# ASSESSMENT REPORT – DG ADVICE

**REPORT****AS1940:2017 DESIGN COMPLIANCE**

**CLIENT:** Blue Pacific Construction  
**ADDRESS:** Blue Pacific Constructions Pty Ltd  
 Beach Road Palm Beach NSW 2108

**TFA REFERENCE:** 20225  
**TFA CONTACT:** Keith Sharp

Figure 1: Fuel shed location – (extract drawing DA07)

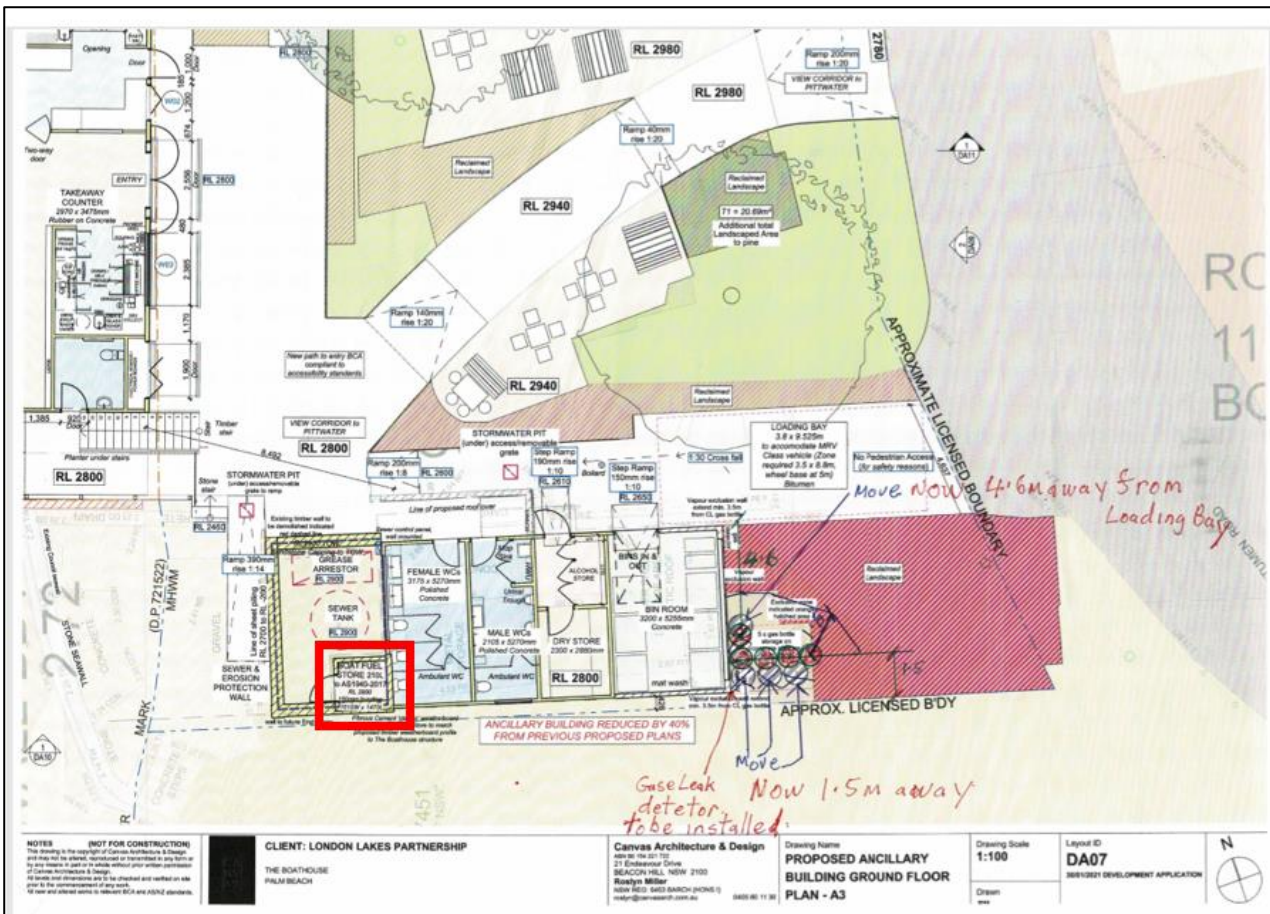
The 210L drum of boat fuel in the proposed fuel store shed is considered minor storage under AS1940 and the proposed installation is in general accordance with the requirements of AS1940.

The nearby sewerage control panel must be installed a minimum of 1.5m above the ground or alternatively moved to a distance of 5m to avoid the hazardous zone.

Based on the above it is noted the sewerage control panel is currently located 4.4m from the fuel store door. To avoid the hazardous zone is shall be installed a minimum of 1.5m above the ground or moved to a distance of 5m.

- Include operating procedure (refer section 5 above and section 9 - AS1940:2017 for guidelines)
- Store to be clear of combustible vegetation/refuse for a distance of at least 3m
- Fuel shed to be lockable and non-combustible construction
- Only hazardous certified electrical equipment to be installed in hazardous areas as described in section 3.1 above.
- The sewerage control shall be installed a minimum of 1.5m above the ground or moved to a distance of 5m.

Figure 2: LPG Cylinder location (extract drawing D07)

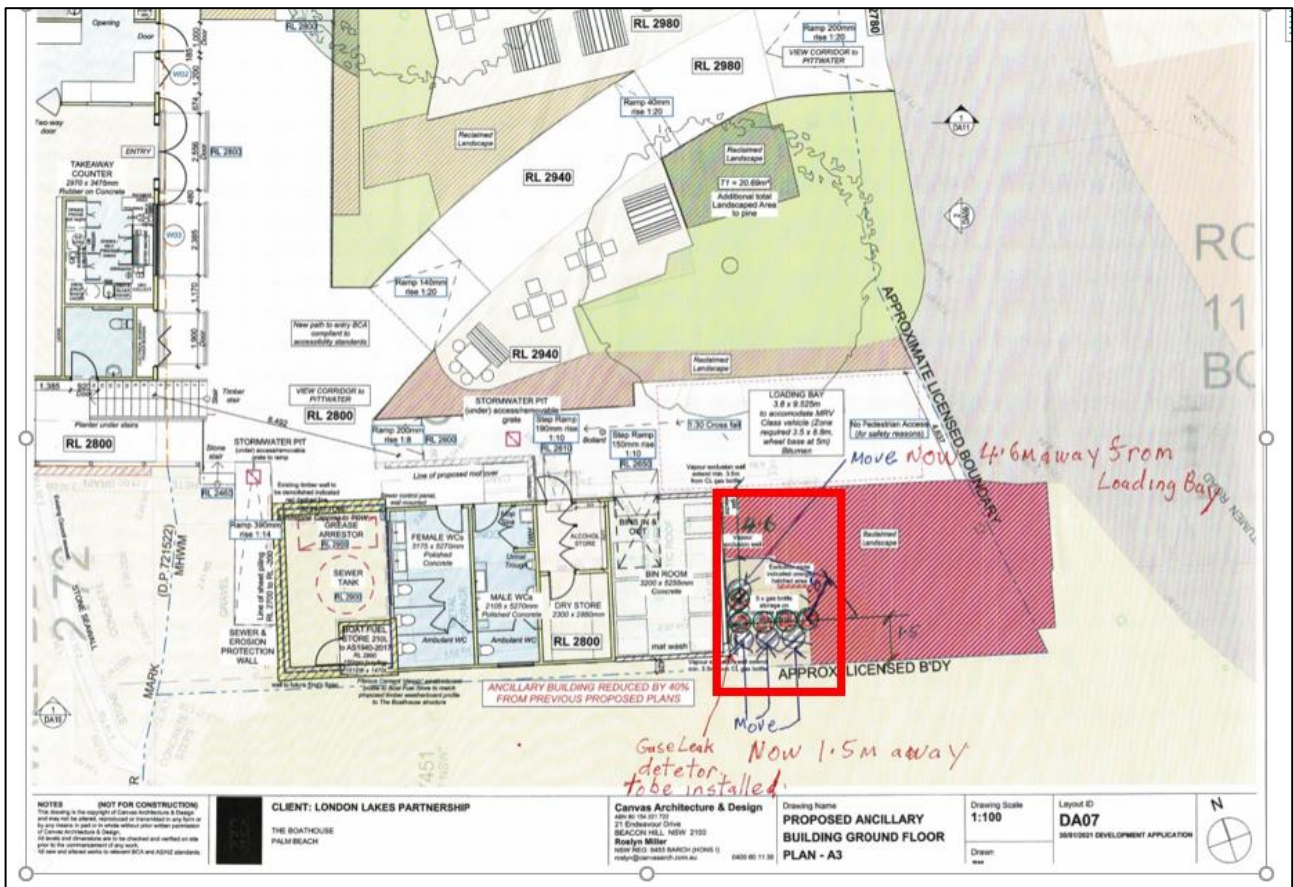
- Position of bottles as shown in figure 2.
- Distance to closest edge of loading bay has been increased from 2.9m to 4.6m from LPG bottles.
- Delivery trucks are now located outside the hazardous zone.

Based on the above assessment, the proposed location for the LPG storage in figure 2 is considered in general accordance with the requirements of AS1596.

- Distance to outside edge of parking bay previously noted as 2.9m. This distance is now 4.6m;
- As the parking bay is 3.8m wide and a typical MRV CLASS VEHICLE is 2.5m, it is highly unlikely that the truck would impede the reclaimed landscape area.

- The parking area to the east of the LPG bottles (as illustrated in previous report) is now a landscape area only
- In addition an LPG detector and light is proposed to be installed. It is recommended the LPG detector is installed at the loading bay end of the cylinders near the ground. The light should be in an easily visible location for staff and delivery personnel;

- The window in the adjacent wall are proposed to be a minimum of 600mm above the cylinders outside the hazardous zone;
- The proposed vapour barrier walls extend 3.5m horizontally from the cylinders effectively preventing the hazardous zone from extending into the bin enclosure.

- Cylinders should be stored on a concrete pad upright and prevented from falling.
- It is recommended the LPG detector is installed at the loading bay end of the cylinders near the ground. The light should be in an easily visible location for staff and delivery personnel.
- Unloading of trucks at the loading bay should not be permitted if an LPG leak is detected or during in-situ filling of the LPG cylinders.
